REVIEW OF WATERFORD III BASEMAT ANALYSIS

Structural Analysis Division
Department of Nuclear Energy
Brookhaven National Laboratory
Upton, NY 11973

July 18, 1984

FIG 4 BOUNDARY CONSTRAINTS

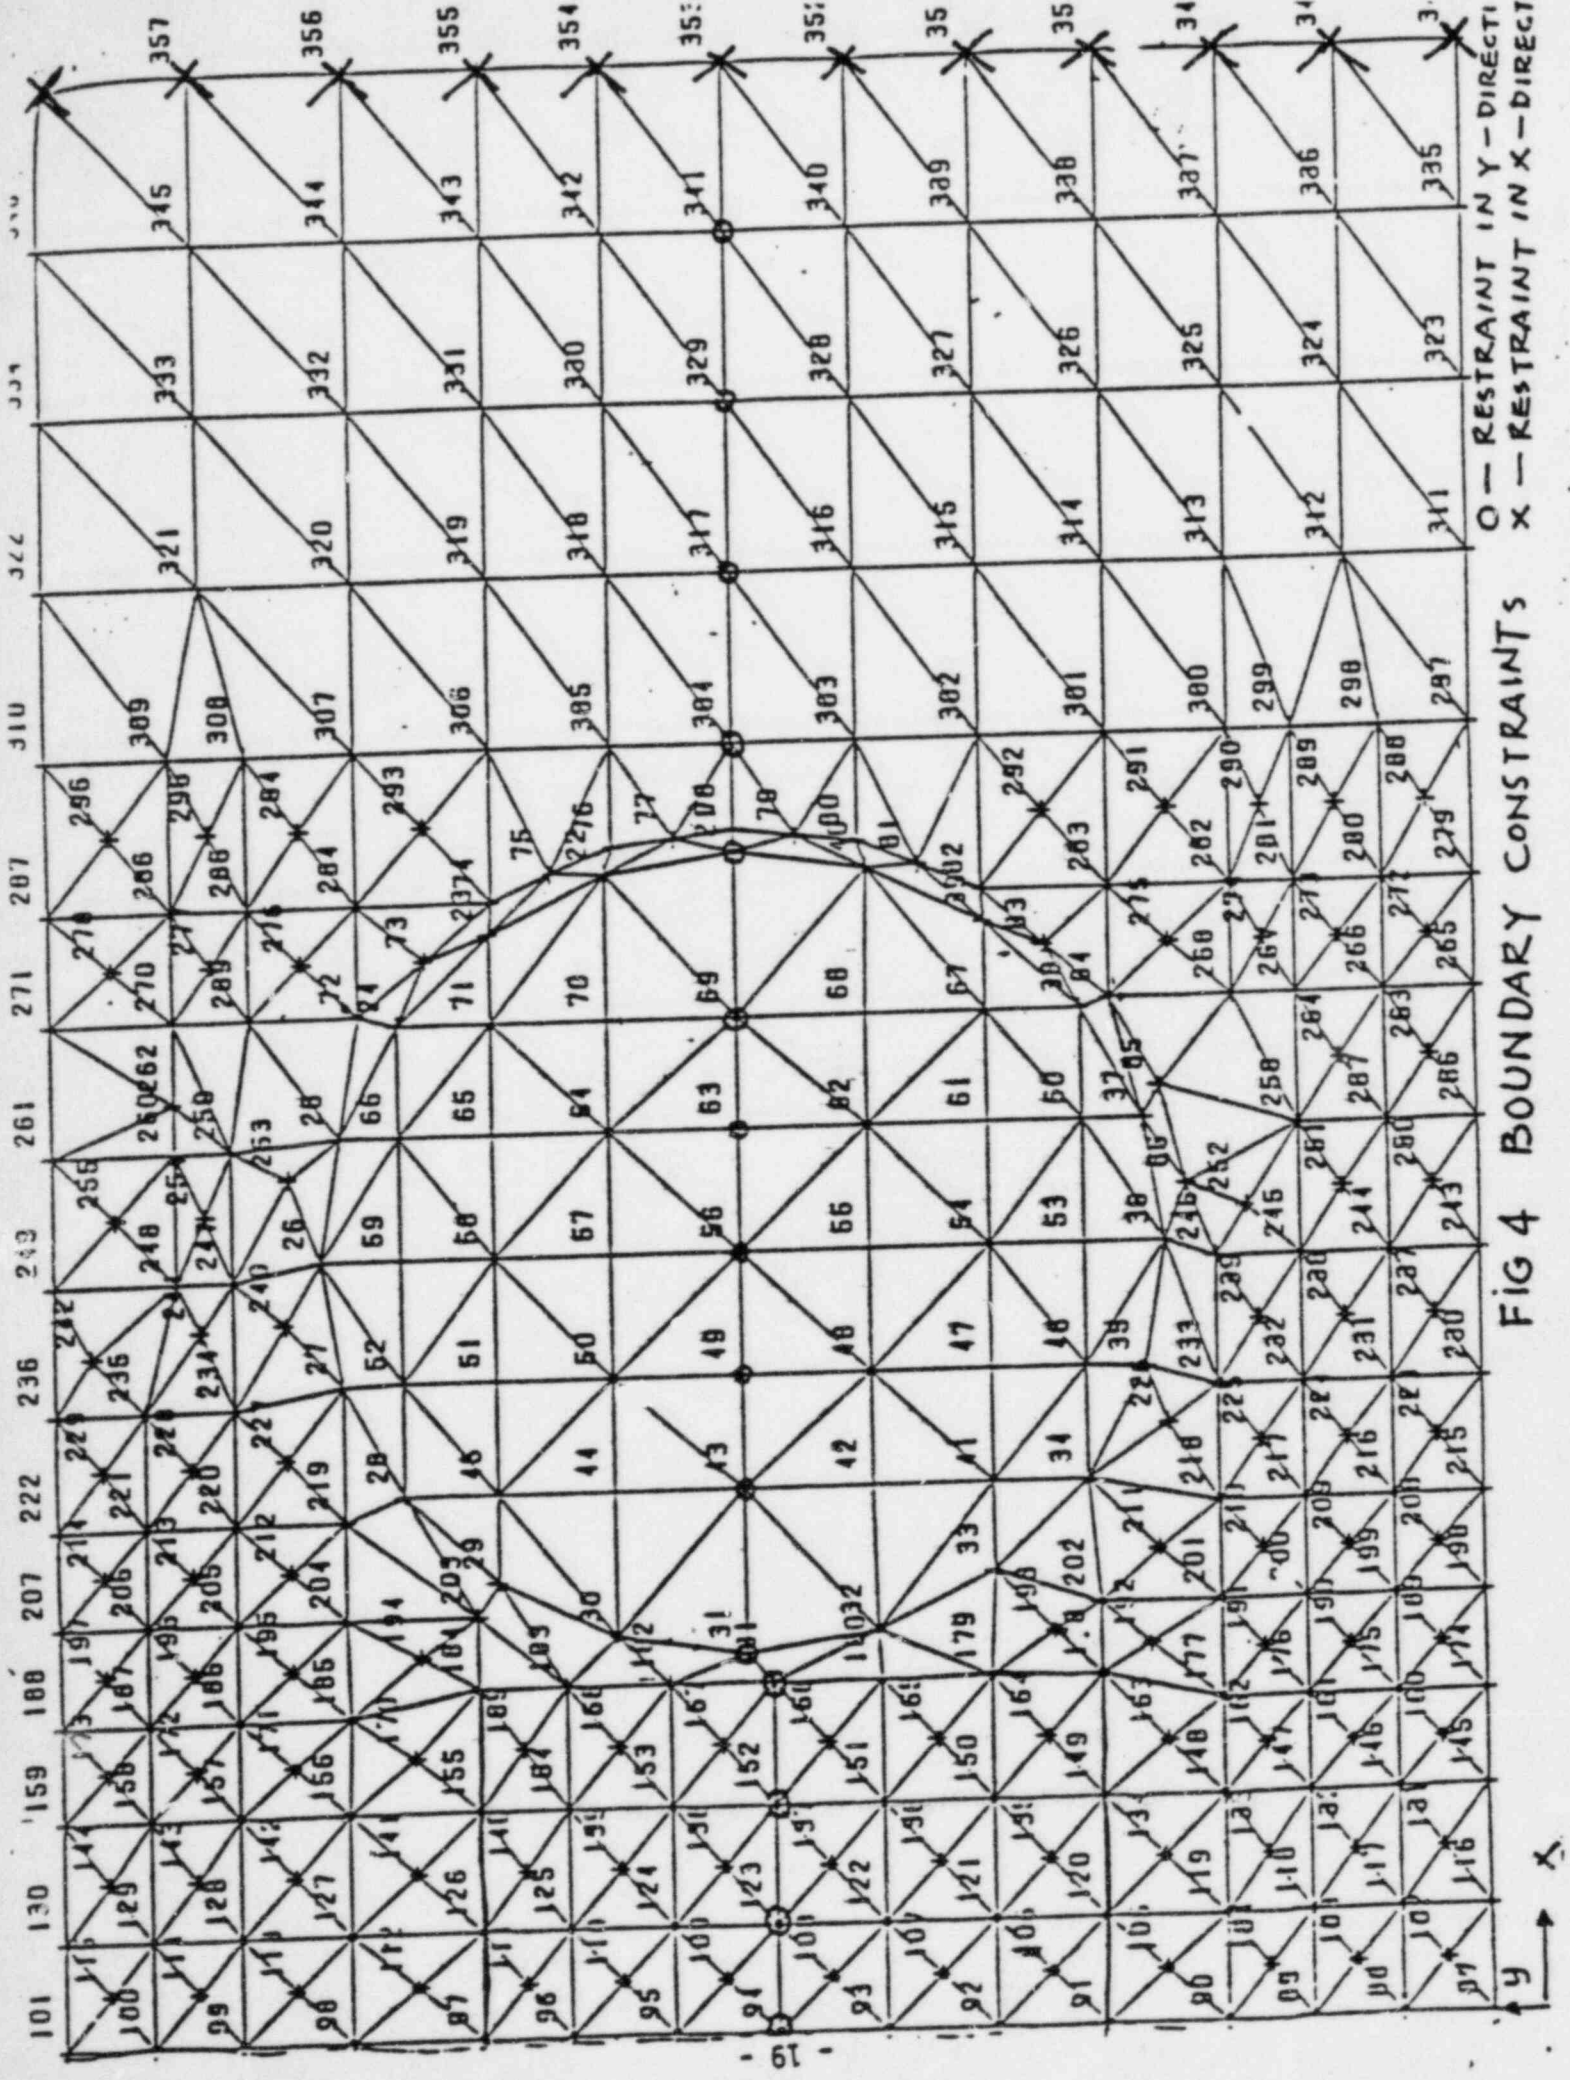
model. The constraints are depicted in Fig. 4. The nodes shown circled were constrained from movement in the y (east-west) direction, while those described by "x" were constrained in the x (north-south) direction. As is commonly practiced in finite element applications, the constraints are placed in a manner that they do not overly affect the static and dynamic response calculations. From the output presented in the EBASCO and HEA reports, this effect was not evaluated. The stresses caused by the artificial boundaries should be calculated and compared with those presented.
